**RAI 03.07.01-27, Supplement 1, Revision 1**

**Follow-up Question to RAI 03.07.01-19 (STP-NRC-100093)**

**REVISED SUPPLEMENTAL RESPONSE:**

**RAI 03.07.01-27, Supplement 2, Revision 1**

**Figure 03.07.01-27.13 - 5% Damped Spectral Comparison in Y Direction at Top of Roof Slab (Corner near access room), El. 30.0 ft**

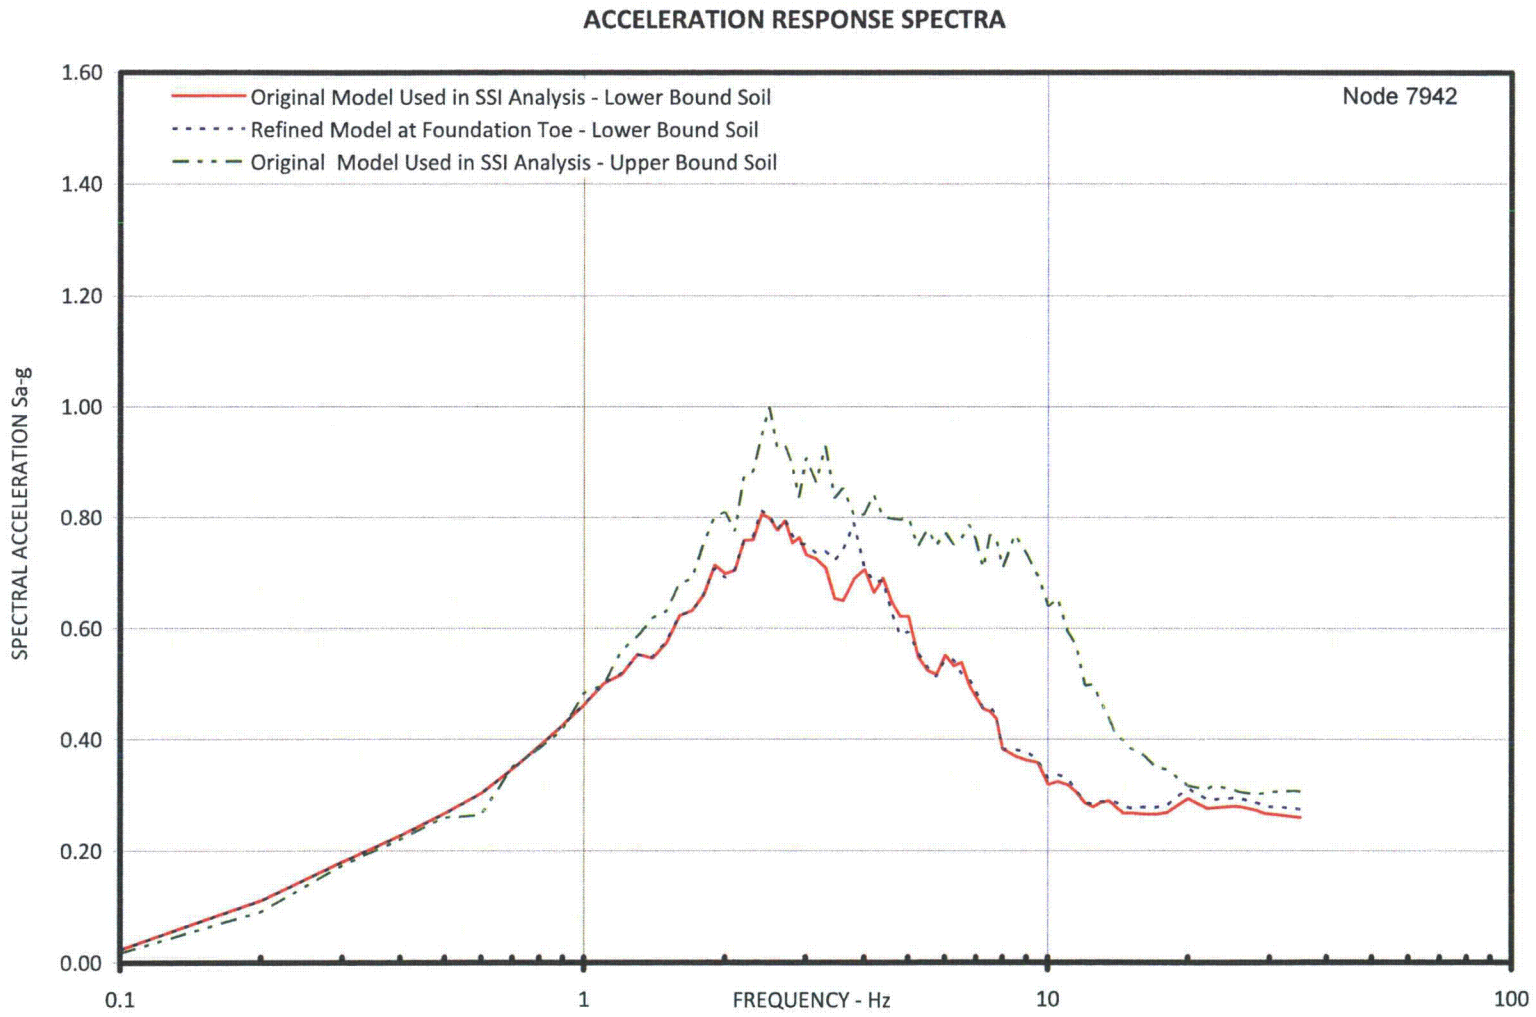
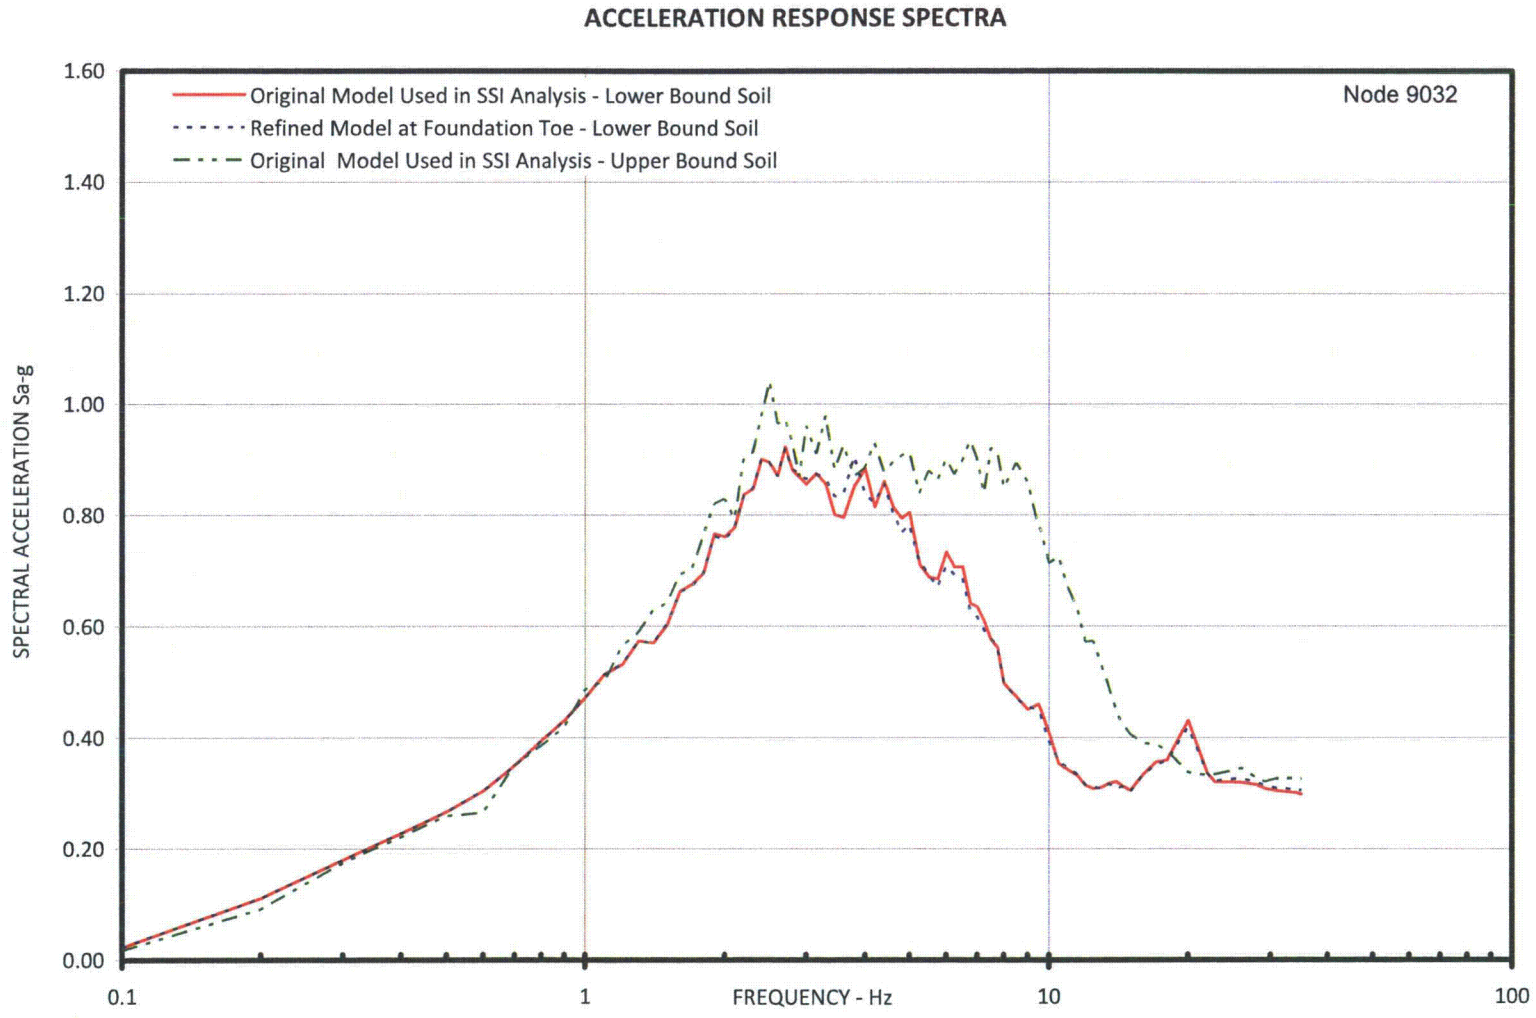
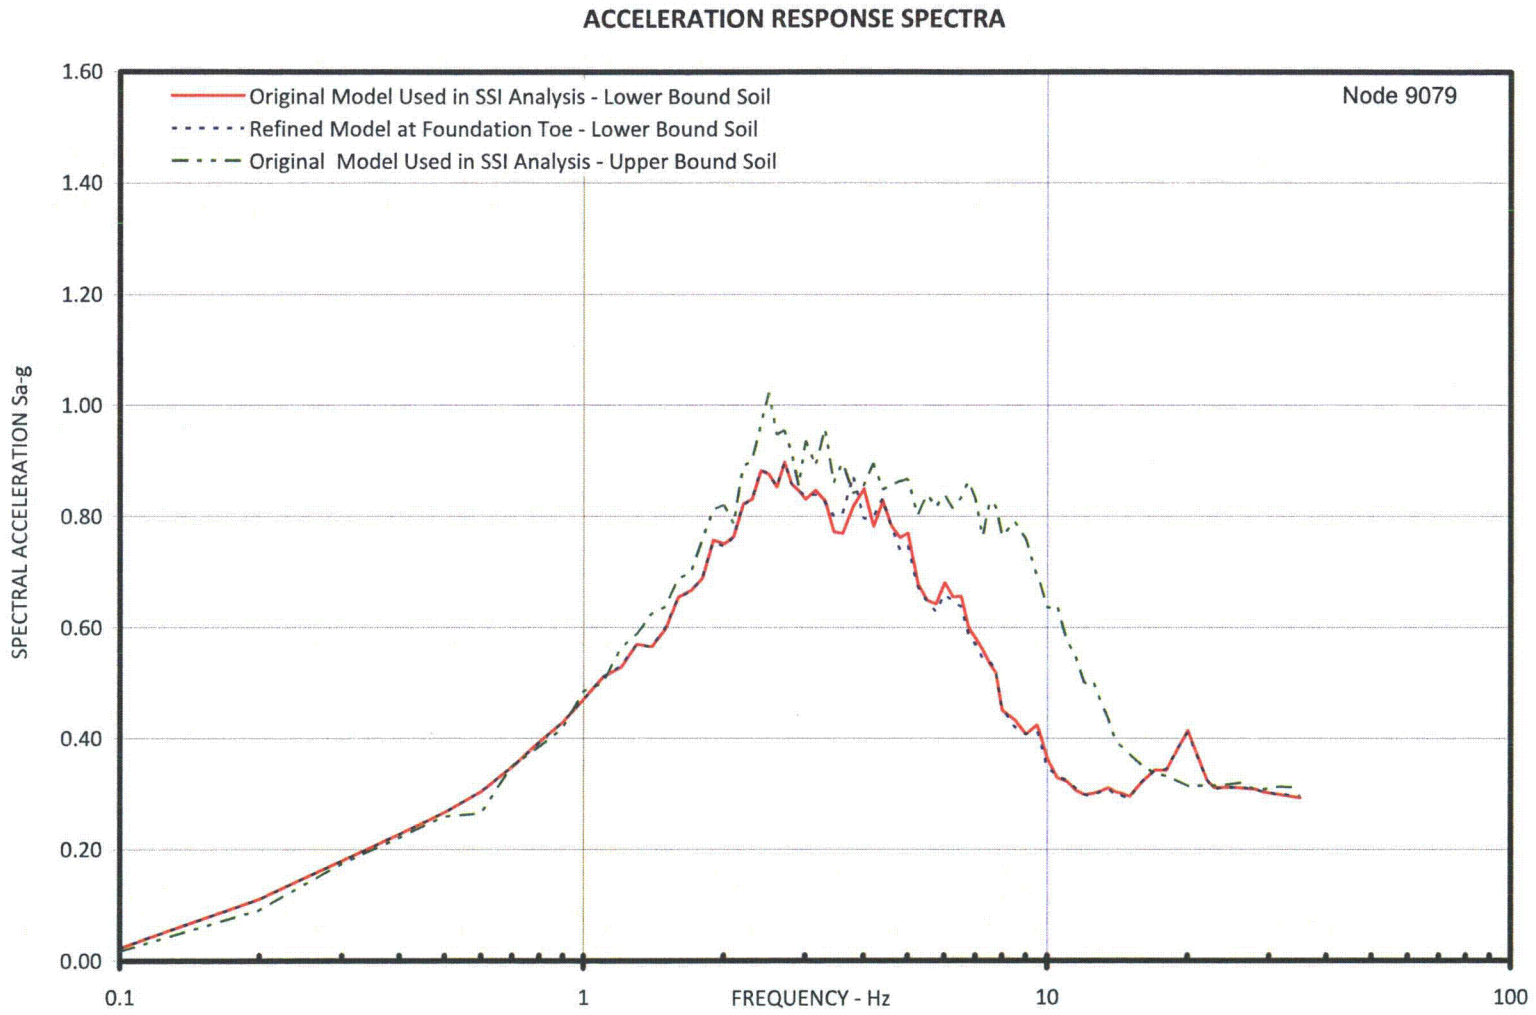
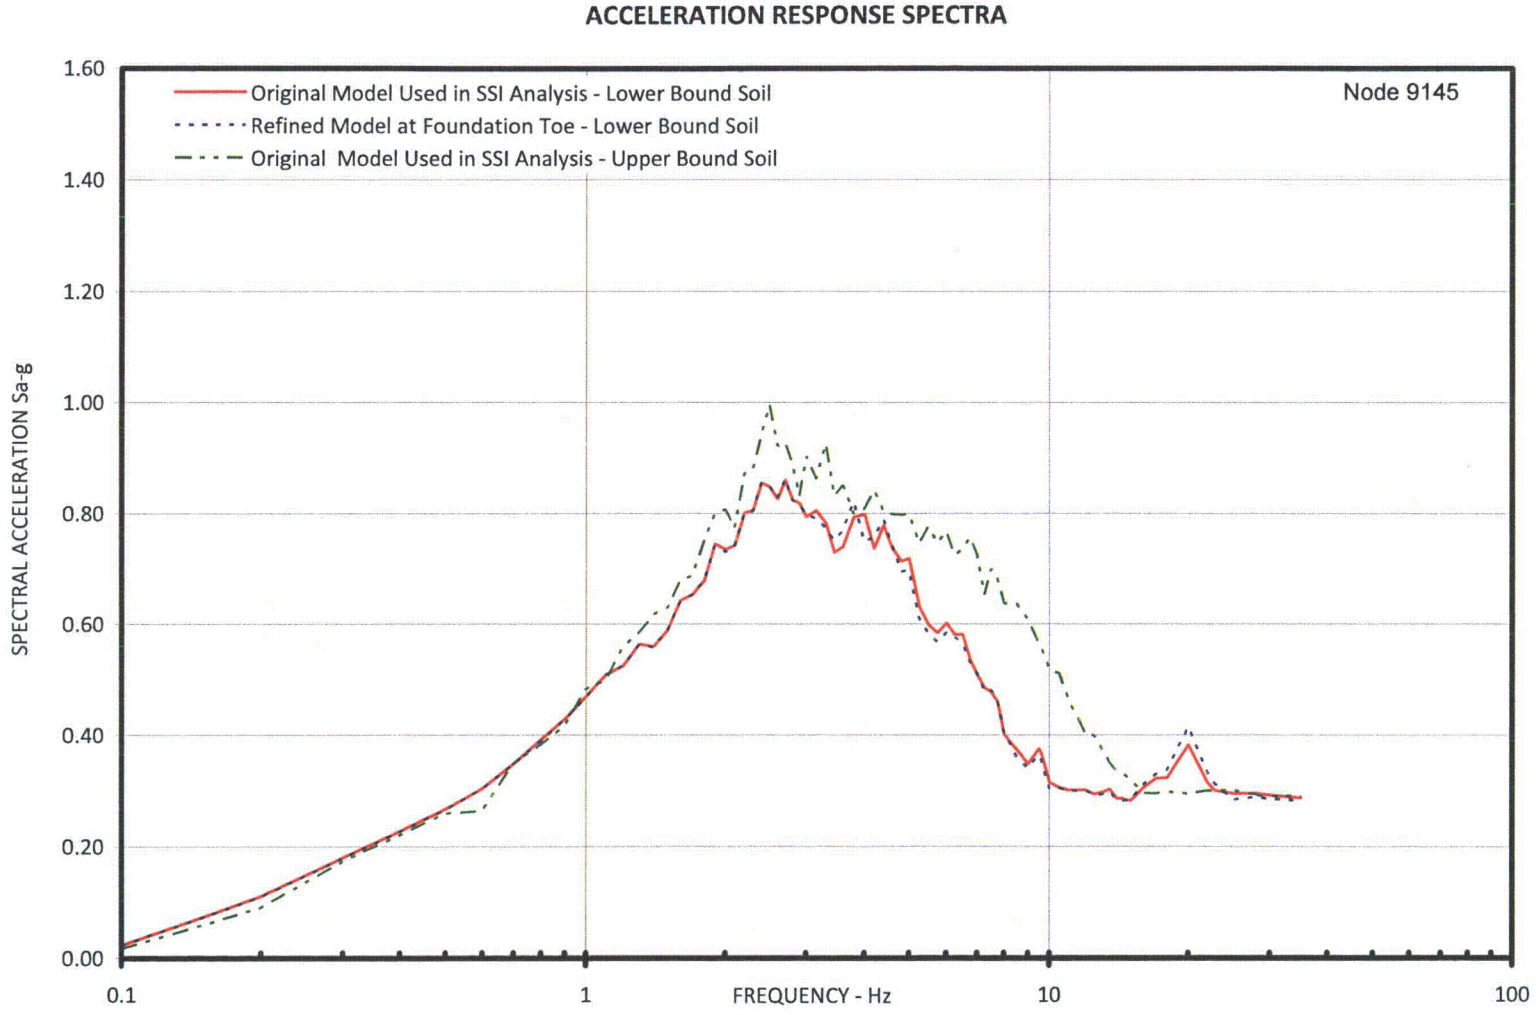
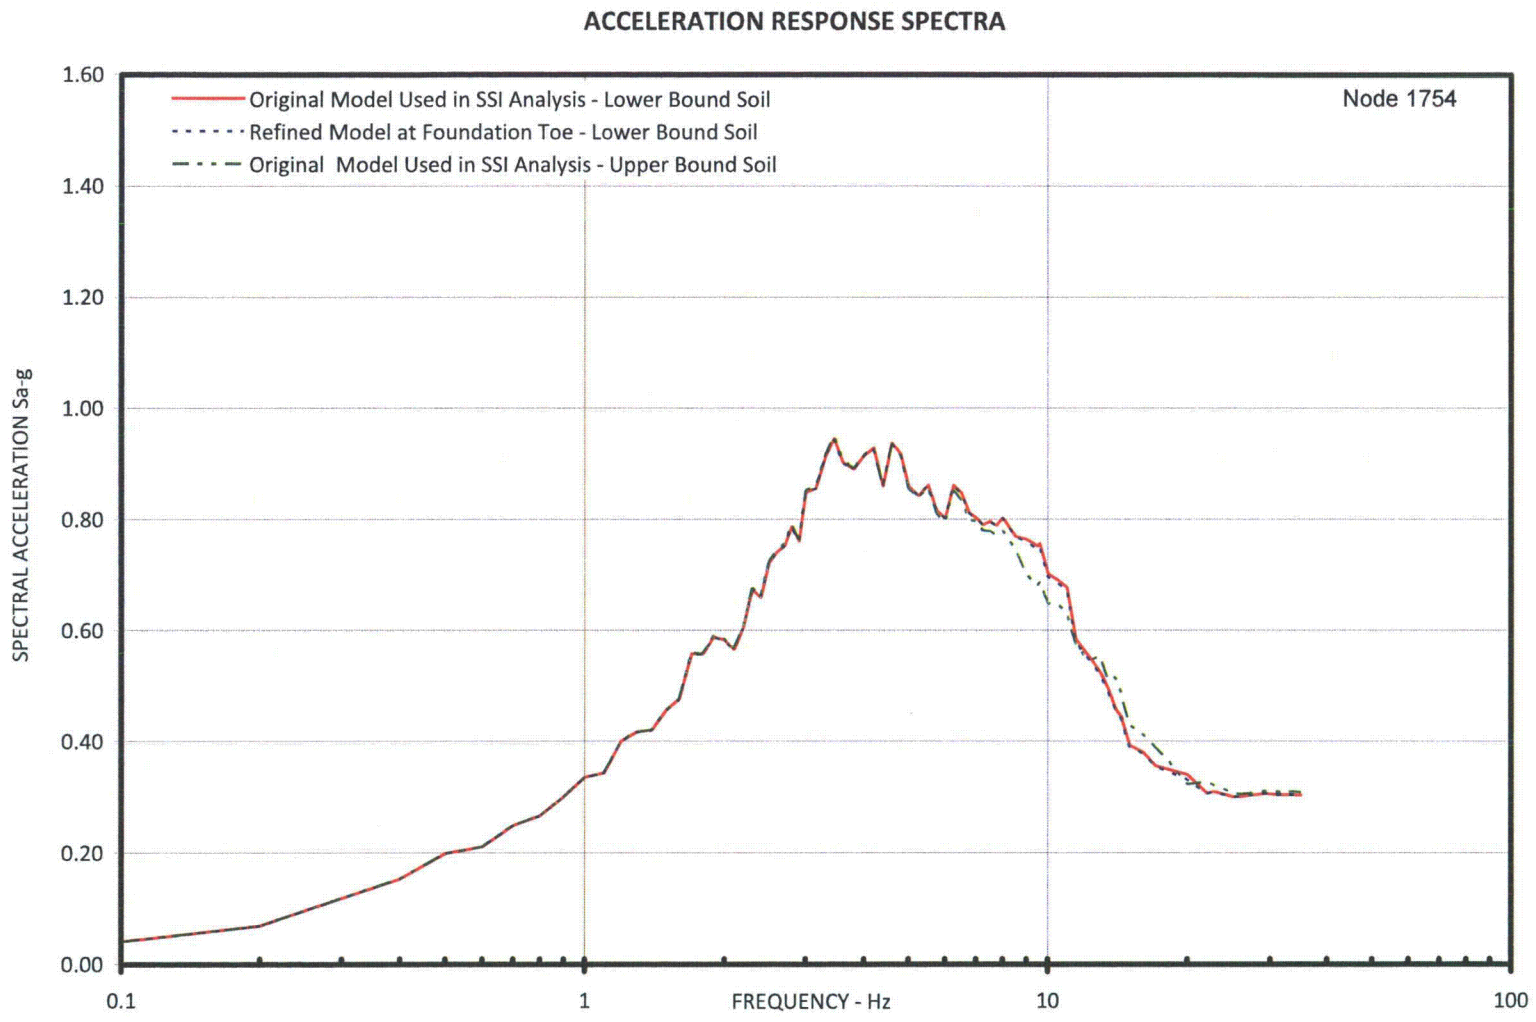
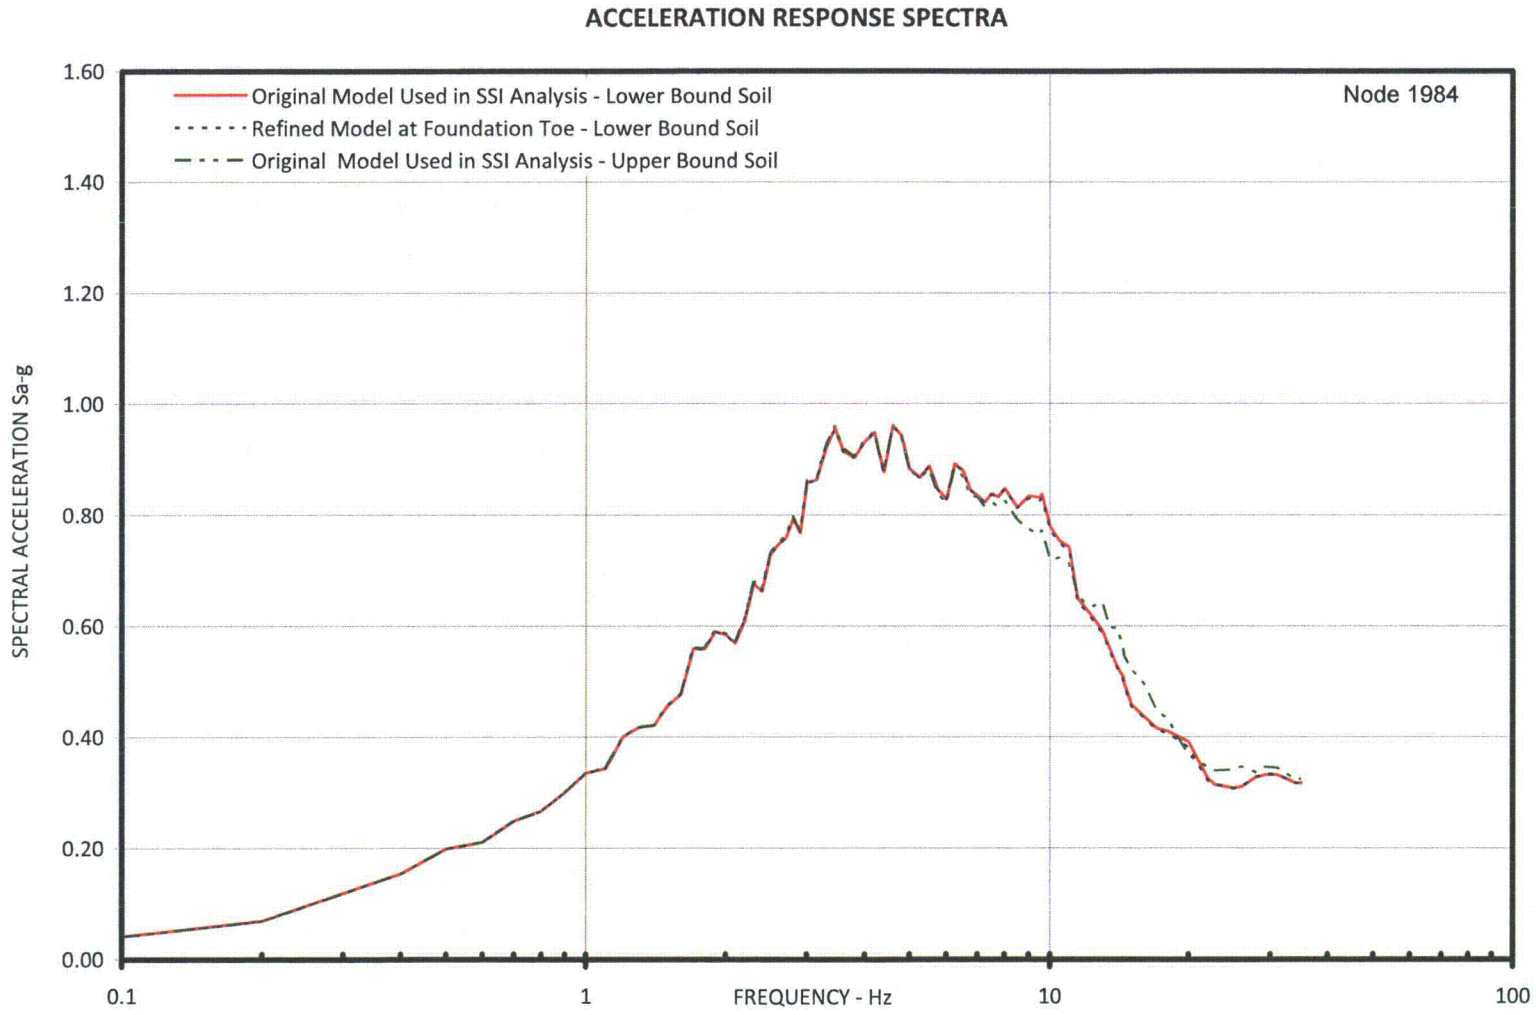
1. 10CFR50, Appendix S requires that evaluation for SSE must take into account soil-structure interaction (SSI) effects and the expected duration of vibratory motion. In the response to the first paragraph of RAI 03.07.01-19, the applicant has presented its approach for developing the input motion for the SSI analysis and design of the DGFOSV that takes into account the impact of the nearby heavy RB and RSW Pump House structures. The applicant also stated that *"Conservatively, a 3-dimensional SAP2000 response spectrum analysis was used to obtain the safe-shutdown earthquake (SSE) design forces due to structure inertia. The seismic induced dynamic soil pressure on DGFOSV walls were computed using the method of ASCE 4-98, Subsection 3.5.3.2"* The response, however, does not provide details as to how the SSI analysis of the DGFOSV are performed and how the input motion developed are subsequently specified in the SSI analysis of DGFOSV to develop the structural response and in-structure response spectra for any equipment and subsystems within DGFOSV. From the response it appears that the applicant has not included explicitly DGFOSV structural model in the SASSI model of the RB and RSW Pump House structures to properly evaluate the SSSI effect on the DGFOSV. In order for the staff to determine if the evaluation of DGFOSV for SSE has appropriately accounted SSI effects, the applicant is requested to provide in the FSAR the following information:

To evaluate the effect of 20 Hz passing frequency for LB in-situ case, the foundation toe was divided into two elements, thus increasing the passing frequency to 40 Hz. This refined model with LB in-situ soil properties was analyzed and 5% damped spectra from this model were compared with the spectra from the original model with passing frequency of 20 Hz. The spectra comparison plots are shown in Figures 03.07.01-27.1 through 03.07.01-27.24. The comparison shows that:

- In the X direction, there is insignificant difference between the response spectra from the two models
- In the Y direction, the response spectra from the two models matched well except at frequency of about 3.8 Hz where the refined model produced higher spectra.

However, spectra from both the models are enveloped by the spectra for UB in-situ soil case

- In the vertical direction, the spectra from the two models matched well (insignificant difference)

Based on the above evaluation it is concluded that the horizontal direction passing frequencies are acceptable.
